Access Compliance Report

Public Rights-of-Way

(Curb Ramps)

Intersection ID: 20507	Main Street: SARDIS_RD	Cross Street: BOYCE_RD	Location: SW
ADA ID: 2AD132400940	Ramp Type: Perp	Initial Pass/Fail: Fail	Overall Compliance: No
Severity Score: 8.75			
Codes/Mitigation Info/Possible Solution		Field Measurements/Component Compliance

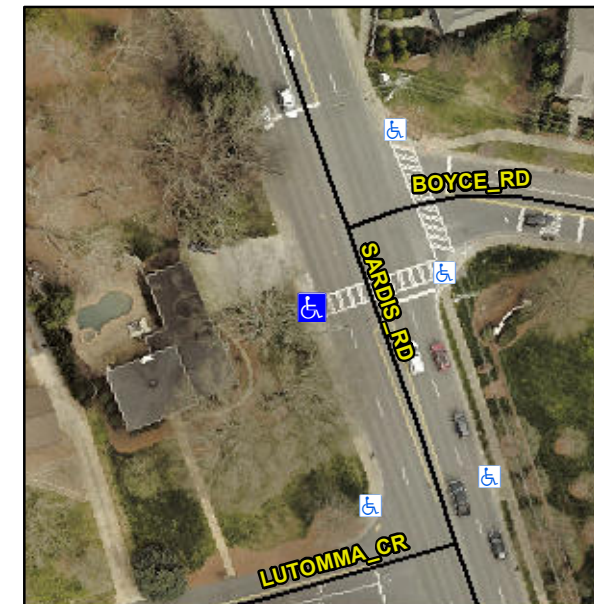
Not Found, R304.5.1

Compliance	Description	Data	Compliance	Description	Data
N/A	Ramp Length (in)	59.0	Yes	Ramp Slope (%)	8.2
No	Ramp Width (in)	46.0	Yes	Ramp XSlope (%)	1.8
N/A	Flare Type LT	N/A	N/A	Flare Type RT	N/A
N/A	Flare Slope LT (%)	N/A	N/A	Flare Slope RT (%)	N/A
N/A	Flare Traversable LT?	N/A	N/A	Flare Traversable RT?	N/A
N/A	Landing Length (in)	N/A	N/A	DWS Provided?	N/A
N/A	Landing Width (in)	N/A	N/A	DWS Contrast?	N/A
N/A	Landing Slope (%)	N/A	N/A	DWS Length (in)	N/A
N/A	Landing X Slope (%)	N/A	N/A	DWS Full Width?	N/A
N/A	Landing Curb? (Y/N)	N/A	N/A	DWS Offset (in)	N/A
N/A	Shared Landing?	N/A			
N/A	Gutter Ponding?	N/A	N/A	Gutter Slope (%)	N/A
N/A	Gutter Lip Ht (in)	N/A	N/A	Gutter X Slope (%)	N/A
N/A	Painted X Walk1?	Yes	N/A	Painted X Walk2?	N/A
	X Walk 1 Direction	To E		X Walk 2 Direction	N/A
N/A	X Walk 1 Width (in)	112.0	N/A	X Walk 2 Width (in)	N/A
	X Walk 1 Slope (%)	3.2		X Walk 2 Slope (%)	N/A
	X Walk 1 X Slope (%)	2.5		X Walk 2 X Slope (%)	N/A

Remove & Replace Entire Ramp.
